May 17<sup>th</sup>, 2019

**Product Change Notification for Littelfuse Varistors Products**

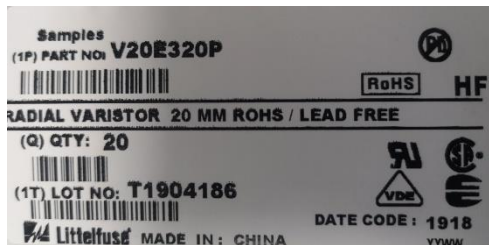
Littelfuse would like to notify you of a change relating to the UL and CSA logo marking on product surface and product packaging label (inner packing box). All current MOVs UR logo marking will be changed to cURus and the current CSA logo will be removed based on UL 1449 4<sup>th</sup> Ed. Rev: 2018-08-01 and CSA C22.2 No. 269.5-17, 2017-09 evaluation listed in UL file# E320116 (VZCA).

Current UR and CSA marking on product surface

New cURus marking on product surface

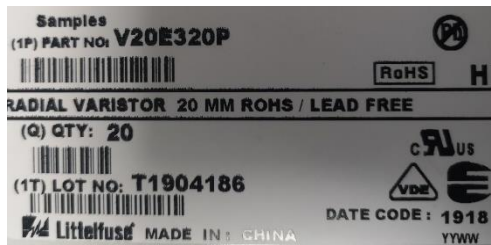
Current label with UR and CSA marking

New label with cURus marking
